INTERNATIONAL PRELIMINARY EXAMINATION REPORT

Applicant's or agent's file reference P200201190 WO		FOR FURTHER ACTION See Notification of Transmittal of International Preliminary Examination Report (Form PCT/IPEA/416)					
International application No. PCT/DK 03/00568		International filing date 01.09.2003	(day/monti	n/year)	Priority date (day/month/yea 02.09.2002	ar)	
Internation A61M3		tent Classification (IPC) or bo	l oth national classification	and IPC			
Applican UNOM		AL A/S ET AL.

PCT/DK 03/00568

2/4

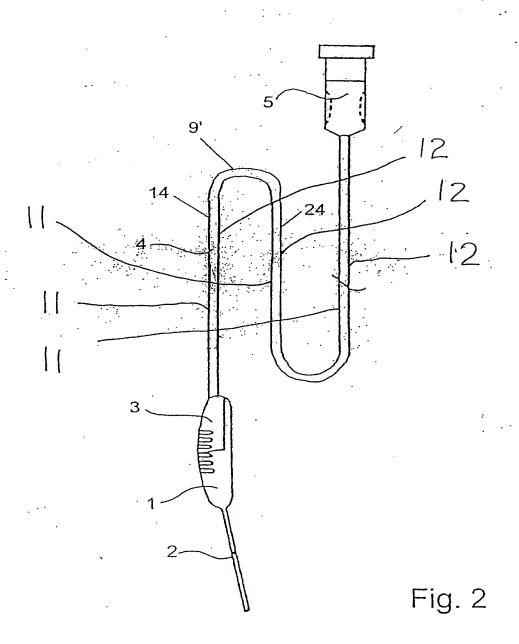
- 1. It appears to be no basis in the originally filed application, Article 34(2)(b) PCT, for the deletion of the passage "arranged diametrically opposite the groove (12)" from claims 1 and 7 which otherwise correspond to originally filed claims 1 and 6. There is no indication suggesting that any positioning is possible or that the above mentioned positioning is optional.
- The applicant has indicated that a basis may be found at page 5, lines 1-15. However this passage refers to figures 3a and 3b where the positioning of the protrusion and the groove is arranged as defined in originally filed claims 1 and 6.
- Therefore the assessment under Section III and V below has been done on the basis that above mentioned deletion never took place.

- 1. Claims 1-4 and 7 do not contain any or sufficient information regarding how the folding of the tubing may occur, Article 6 PCT. In the claims it is defined that the tube shall comprise a longitudinally extending external groove (12) and an external protrusion (11) where the groove and the protrusion are arranged on diametrically opposite sides of the tube. Should the skilled reader try to fold such a tube he will be confronted with the problem that the groove or protrusion will face each other disabling any connection. It appears to the examining division that each fold must be performed with a back-and-forth 180° turn of the tube with each folding turn in order to mate the groove with the protrusion. However, following experience this is not possible without kinking of the tube which will render the tube occluded. It may be that it could be possible with some very particular material, however, there are no indications in these claims suggesting such a material.

- 1.1 Since the description is silent regarding above mentioned problem the application is regarded as not sufficiently disclosed since the skilled reader cannot find the necessary information enabling him to carry out the proposed invention, Article 5 PCT.
